## **Appendix 9**

### **Noise Impact Assessment**

### **Brandy Hill Quarry Expansion**

### **Noise & Vibration Impact Assessment**

## Appendix A NOISE LOGGING RESULTS

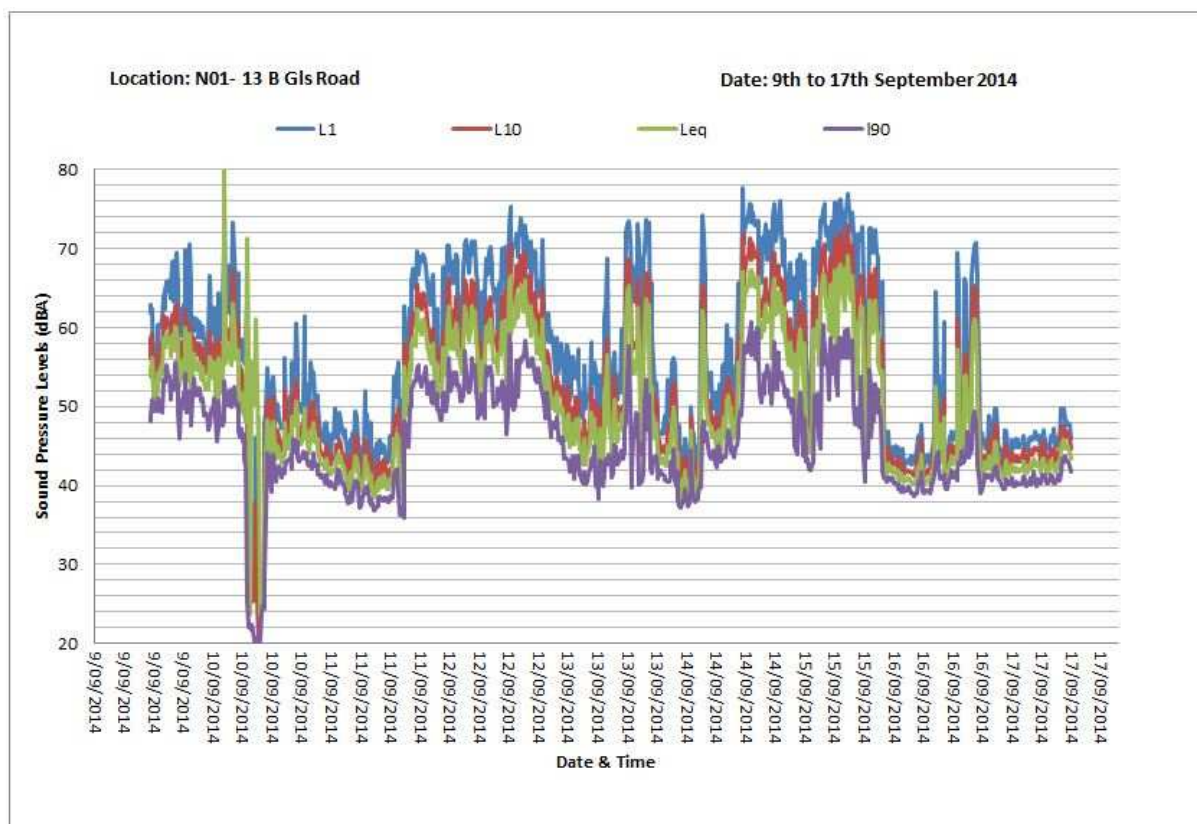
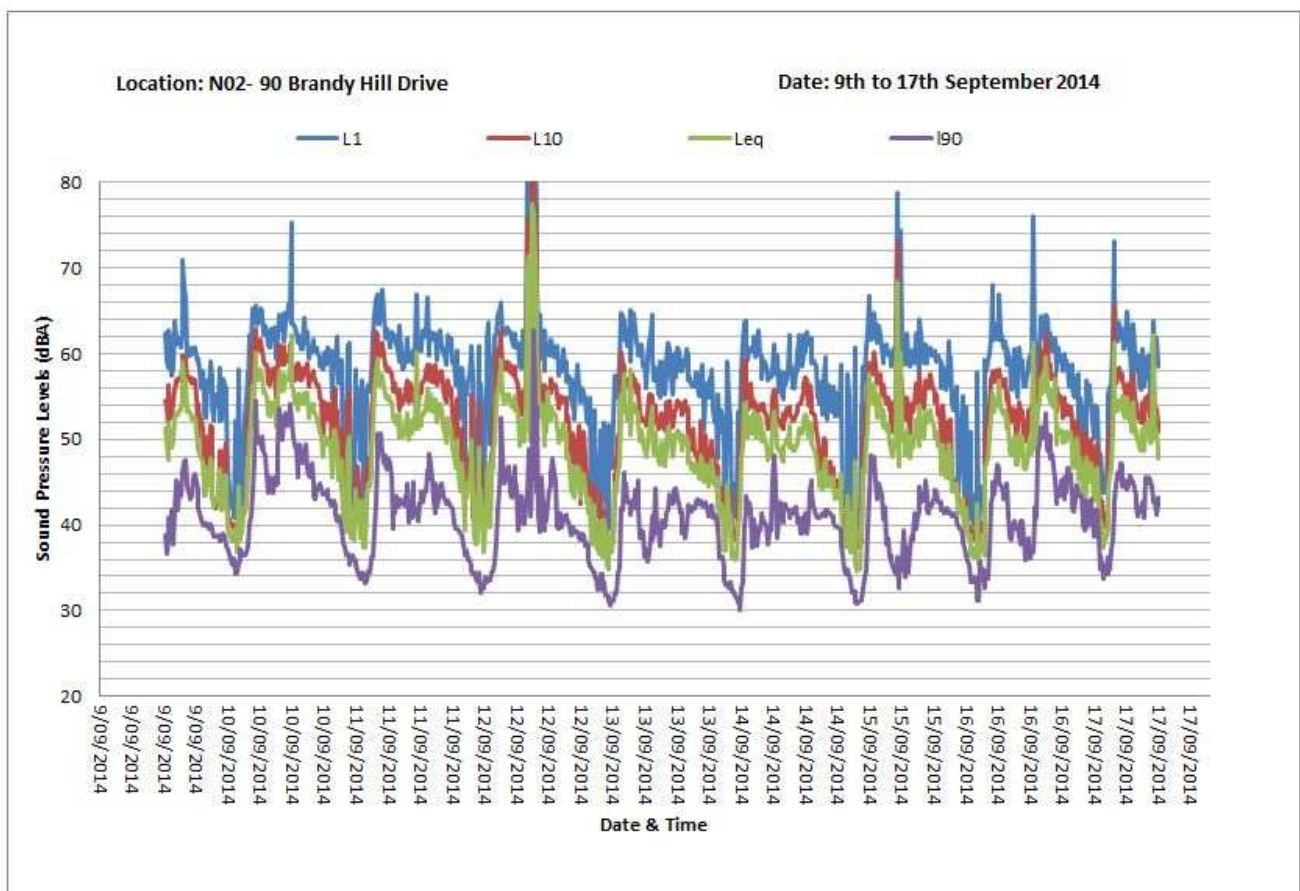
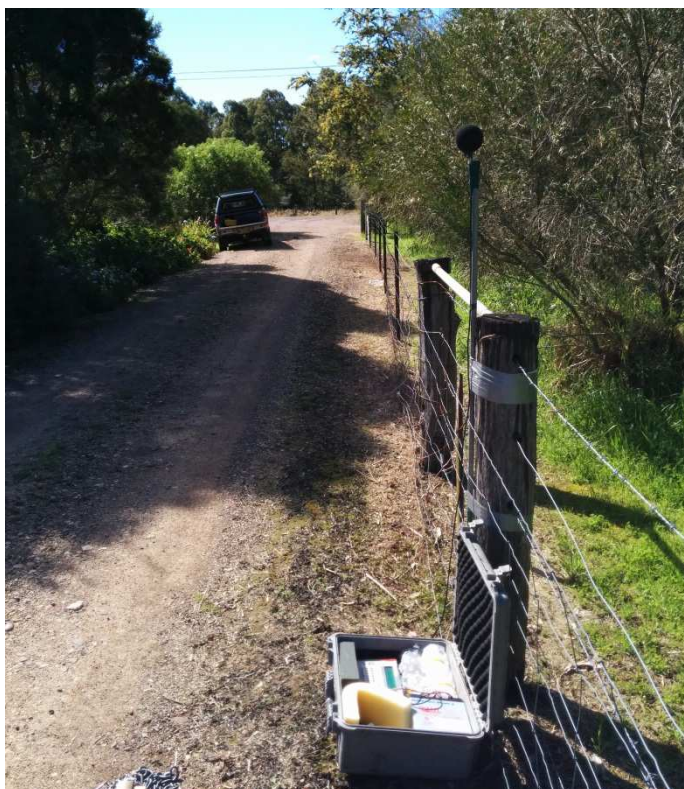
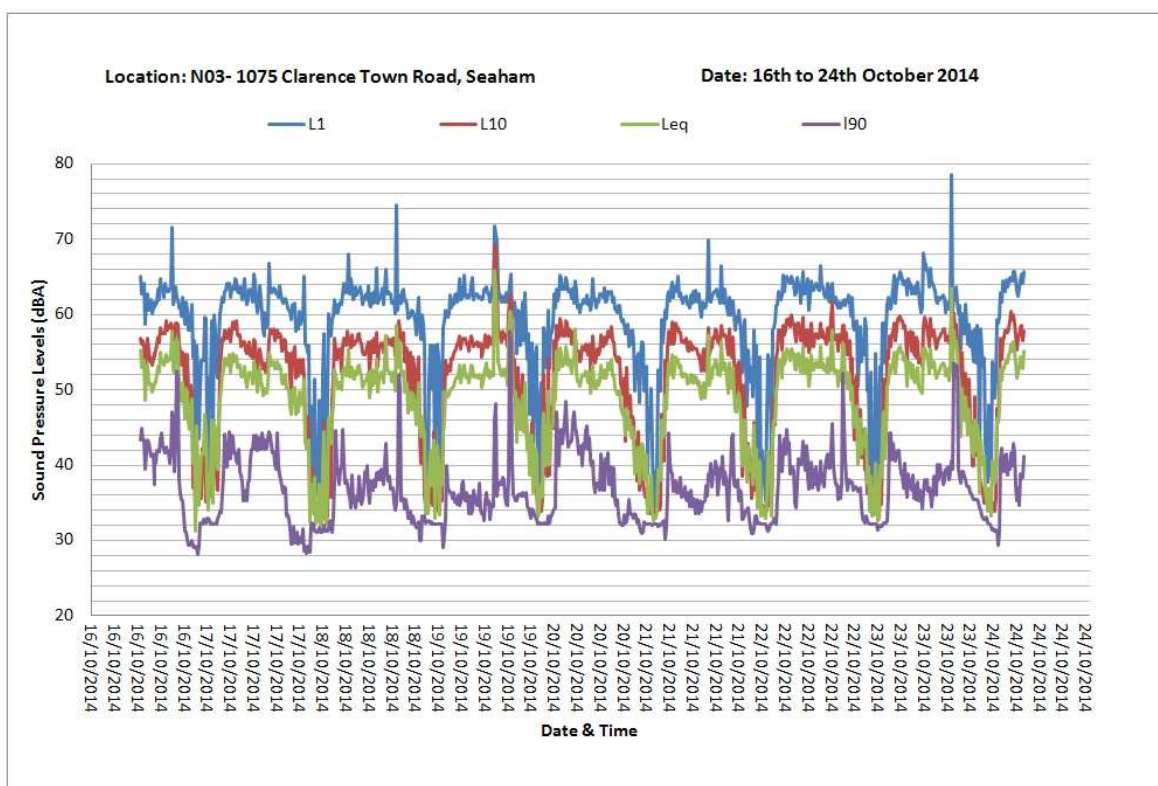
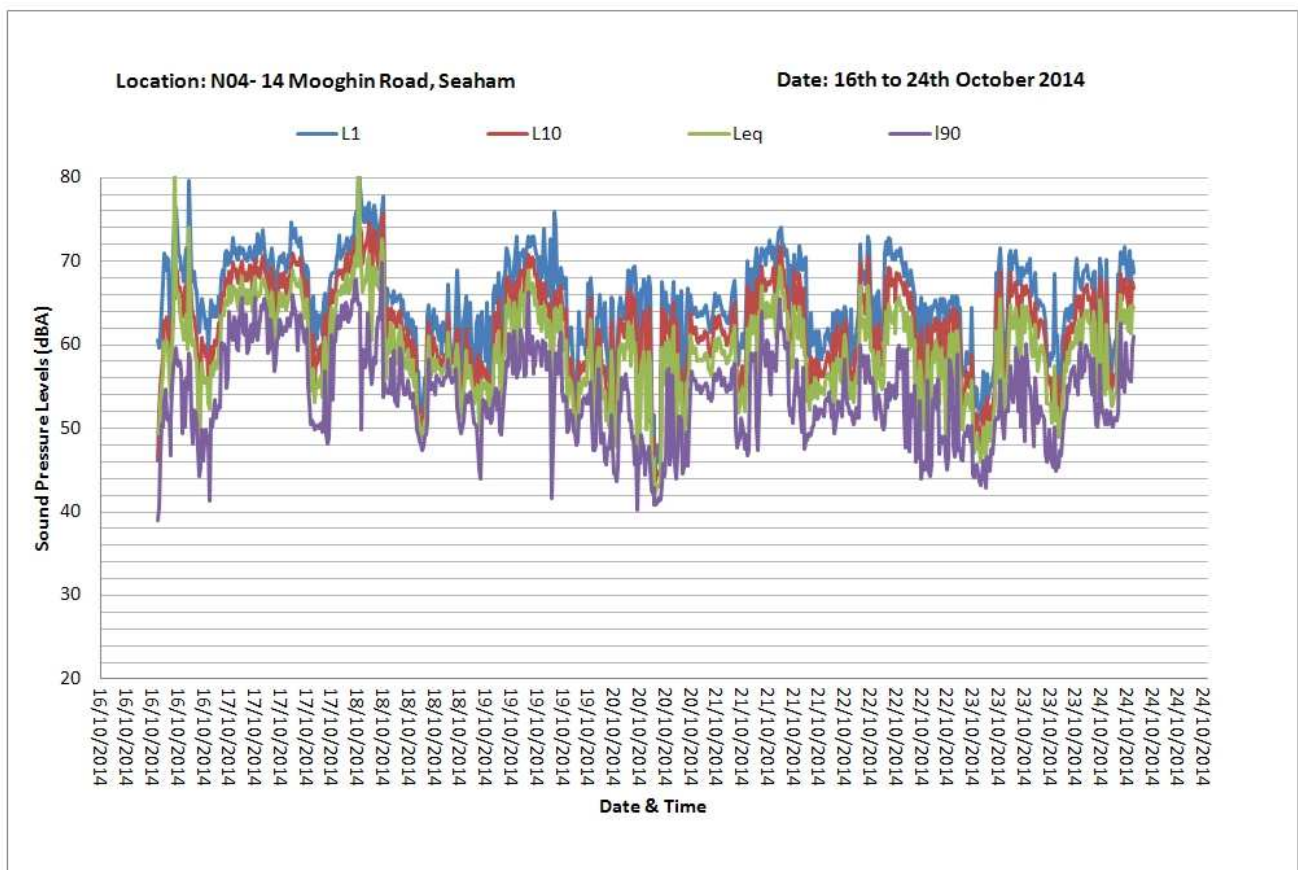
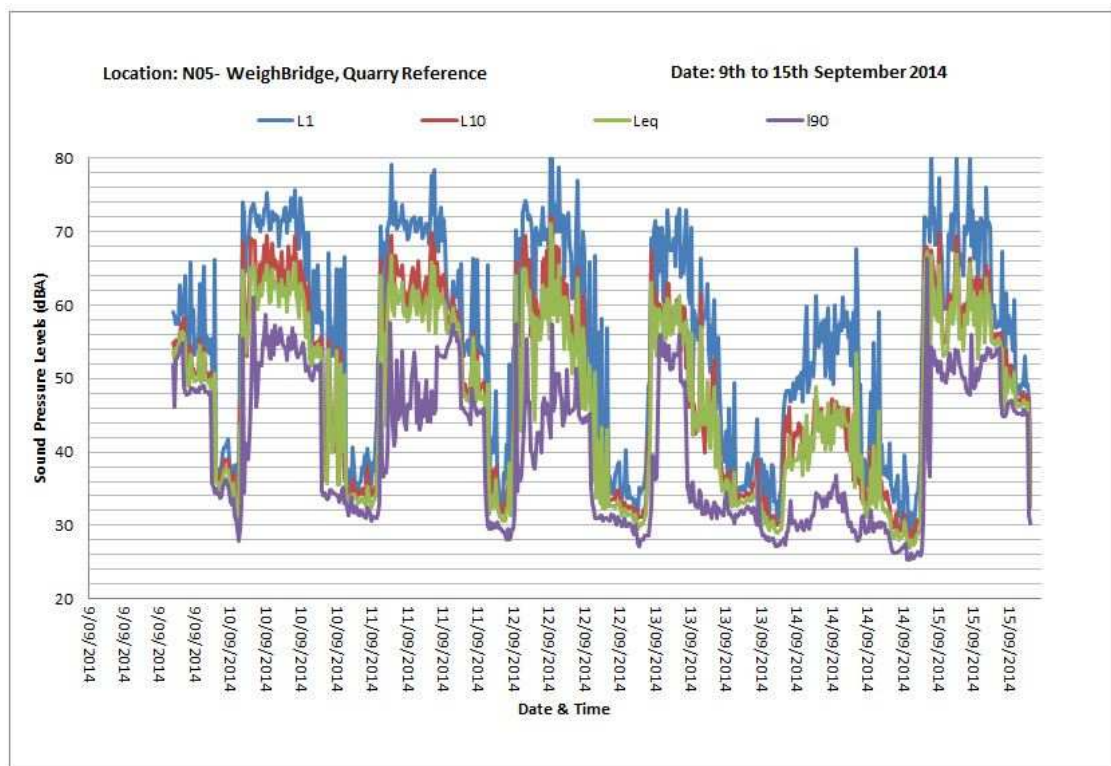
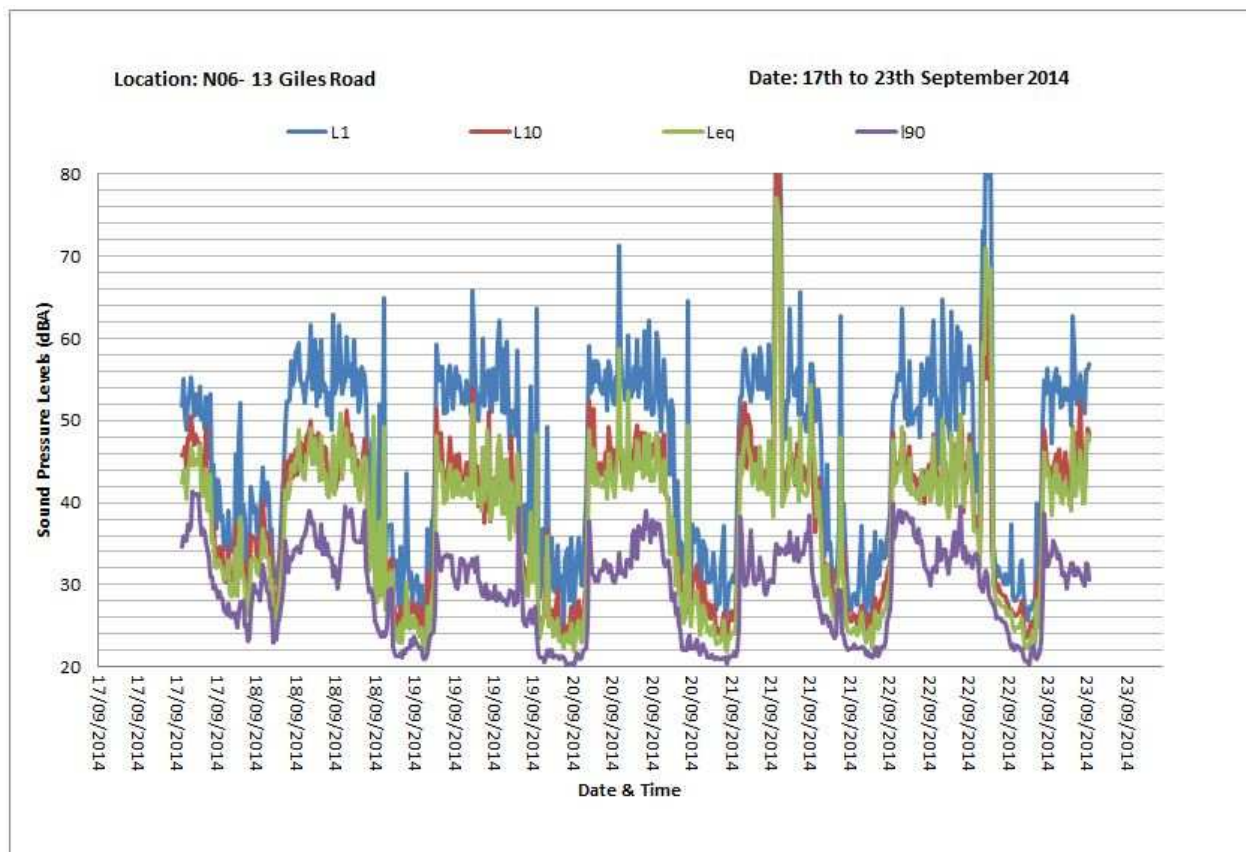
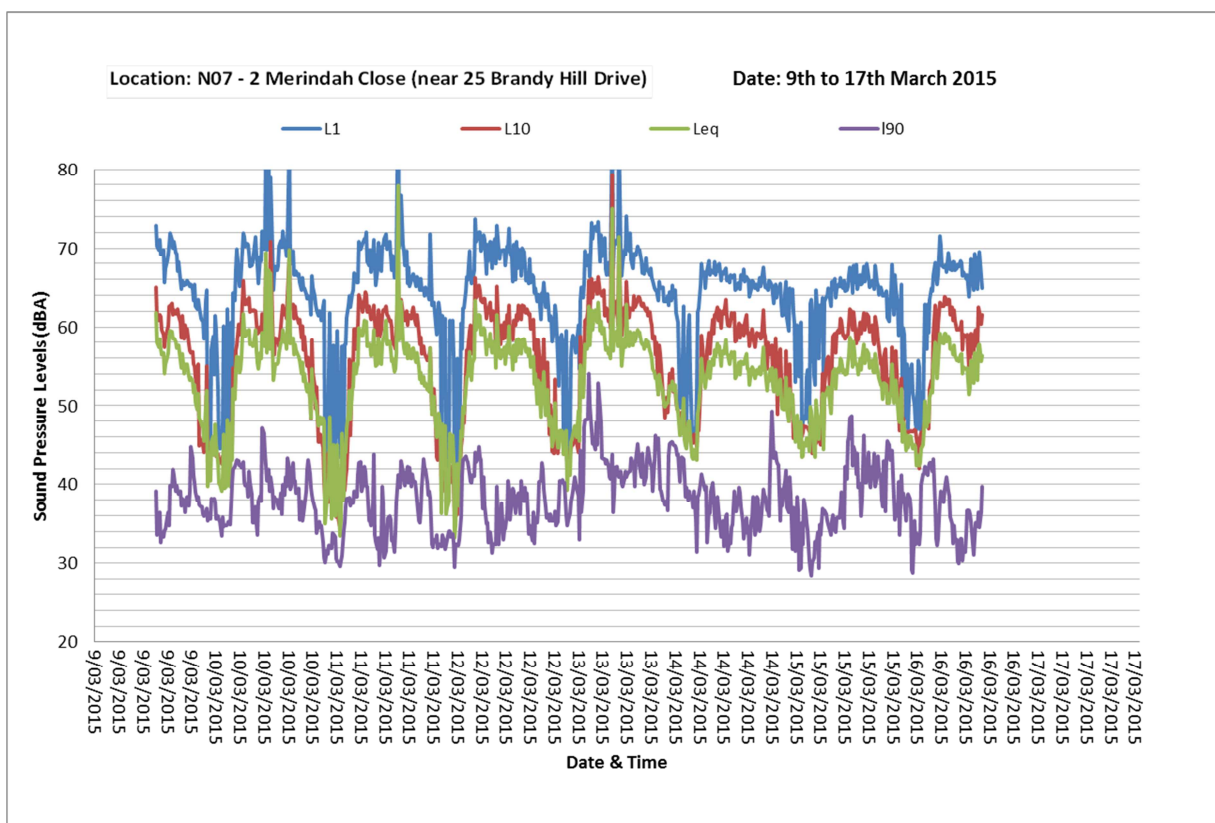
<p>The graphs of N1, N2, N4 and N5 in Appendix A also appear incorrect. It does not seem possible to get the statistical levels that are being presented. It may be that the <math>L_{eq}</math> is being incorrectly labelled as the <math>L_{90}</math>, but there could be a number of other explanations.</p>	<p>Vipac have reviewed the graphs of N1, N2, N4 and N5. The <math>L_{90}</math> and the <math>L_{eq}</math> noise levels labelled in the graphs shown in Appendix A are correct. The <math>L_{90}</math> noise levels, which represent the background noise levels, are shown to have a lower noise level compared to the <math>L_{eq}</math> noise levels for all of the monitoring locations.</p> <p>Vipac have undertaken an additional review of the logged data across the day, evening and night-time periods at each of the noise sensitive monitoring locations N1, N2 and N4. The monitoring location N5 was used as a reference location near the weighbridge at the quarry, as opposed to a baseline monitoring location representative of a noise sensitive receptor. It is noted from the trends in the noise levels that the ambient and background noise levels monitored at the monitoring point N2 are characteristic of the patterns that are observed from locations that are influenced by a combination of environmental and traffic noise sources with similar cycles on a daily basis of the diurnal range in noise levels over each 24-hour period. The trends in the noise levels monitored at the monitoring points N1 and N4 are somewhat more erratic and the patterns are less cyclical over the duration of the noise logging surveys. In addition, it is noted that the range between the statistical noise descriptors is narrower, whereby the variations in the noise levels with time for <math>L_{Aeq}</math> and <math>L_{90}</math> are much closer, than the trends noted for example from the noise logging data recorded at the monitoring point N2.</p> <p>This is indicative of less variation between underlying background noise levels that are periodically interrupted and dominated for example by intermittent passing traffic as would have been evident at the monitoring point N2. The close correlation between the fluctuating ambient and background noise levels as noted from the noise logging trends at the</p>

<p>monitoring points N1 and N4 is somewhat suggestive of natural environmental noise sources, such as fluctuation in insect or bird noise that is generally dominant at the noise monitoring location.</p> <p>However, Vipac cannot definitively comment on the noise sources that led to the fluctuation in the noise levels across the duration of the unattended noise logging surveys. As outlined above, it is acknowledged that the patterns of the RBLs determined during the evening and night-time periods at a number of the noise monitoring locations are unusual, with regard to the level of noise recorded during the evening and night-time period in comparison to the overall daytime noise level trends.</p>
Data for N2 presented in Table 5 is different to that in Table 21	<p>The noise data presented in Table 5 and Table 21 are different because the noise levels presented in both tables relate to two different noise descriptors.</p> <p>For example, the daytime period of relevance to the noise levels listed in Table 5 refers to the noise levels during the (INP) daytime period which extends from 07:00 – 18:00, (11-hour day period), the evening period extends from 18:00 – 22:00 (4-hour evening period) and night-time extends from 22:00 – 07:00 (9-hour night-time period)</p> <p>This is in accordance with the NSW INP Guidelines, which are used when classifying the baseline noise monitoring results into the respective day, evening and night-time periods, with regard to determining the applicable RBL and Project Specific Noise Levels.</p> <p>In contrast, the noise data presented in Table 21 relates to the noise descriptors and the applicable daytime and night-time periods used to assess road traffic noise levels. This is in accordance with the NSW RNP Guidelines, which are used for traffic noise assessment. The daytime period applicable in this regard extends from 07:00 – 22:00 (15-hour day period) and the night-time period extends from 22:00 – 07:00 (9-hour night period). An evening period is not assessed separately as a discreet period with regard to the guidance set out in the NSW RNP.</p>
